NOTICE OF REVISION (NOR)		1. DATE (YYMMDD) 98-07-14	Form Approved OMB No. 0704-0188
THIS REVISION DESCRIBED BELOW HAS BEEN AUTHORIZED FOR THE DOCUMENT LISTED.			
Public reporting burden for this collection is estimated to average 2 hours per response, including the time for reviewing instructions, searching existing data sources, gathering and maintaining the data needed, and completing and reviewing the collection of information. Send comments regarding this burden estimate or any other aspect of this collection of information, including suggestions for reducing this burden, to Department of Defense, Washington Headquarters Services, Directorate for Information Operations and Reports, 1215 Jefferson Davis Highway, Suite 1204, Arlington, VA 22202-4302, and to the Office of Management and Budget, Paperwork Reduction Project (0704-0188), Washington, DC 20503. PLEASE DO NOT RETURN YOUR COMPLETED FORM TO EITHER OF THESE ADDRESSES. RETURN COMPLETED FORM TO THE GOVERNMENT ISSUING CONTRACTING OFFICER FOR THE CONTRACT/ PROCURING ACTIVITY NUMBER LISTED IN ITEM 2 OF THIS FORM.		2. PROCURING ACTIVITY NO.

3. DODAAC	
4. ORIGINATOR	b. ADDRESS (<i>Street, City, State, Zip Code</i>) Defense Suppl

FIGURE A-1

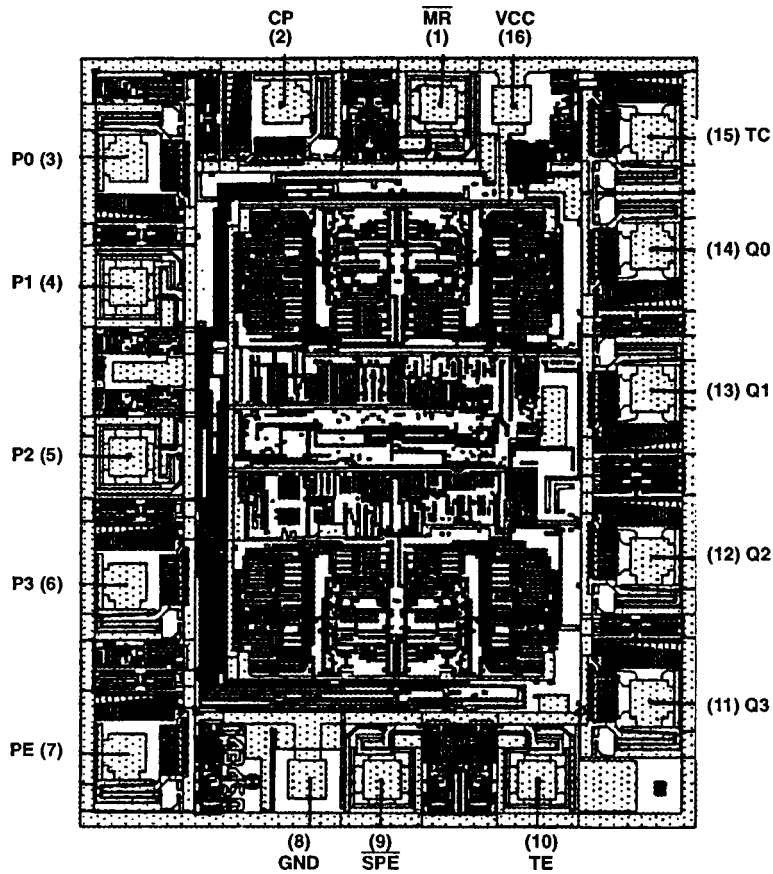
a. CURRENT -	b. NEW A
11. ECP NO. No users listed.			
12. CONFIGURATION ITEM (OR SYSTEM) TO WHICH ECP APPLIES All			
13. DESCRIPTION OF REVISION Sheet 1: Revisions ltr column; add "A". Revisions description column; add "Changes in accordance with NOR 5962-R128-98". Revisions date column; add "98-07-14". Revision level block; add "A". Rev status of sheets; for sheets 1, 4, and 18 through 24, add "A". Sheet 4: Add new paragraph which states; "3.1.1 <u>Microcircuit die</u> . For the requirements for microcircuit die, see appendix A to this document." Revision level block; add "A". Sheets 18 through 24: Add attached appendix A. CONTINUED ON NEXT SHEETS

Die Size: 2650 x 2190 microns.
 Die Thickness: 21 +/- 2 mils.

The following metallization diagram supplies the locations and electrical functions of the bonding pads. The internal metallization layout and alphanumeric information contained within this diagram may or may not represent the actual circuit defined by this SMD.

NOTE: Pad numbers reflect terminal numbers when placed in Case Outlines E, X (see Figure 1).

Top Metallization: SiAl 11.0kA +/- 1kA

Type: SiO2
Thickness 13.0kA +/- 2.6kA

Substrate: Silicon on Sapphire (SOS)

Substrate Potential: Insulator

Special assembly instructions: Bond pad #16 (VCC) first.
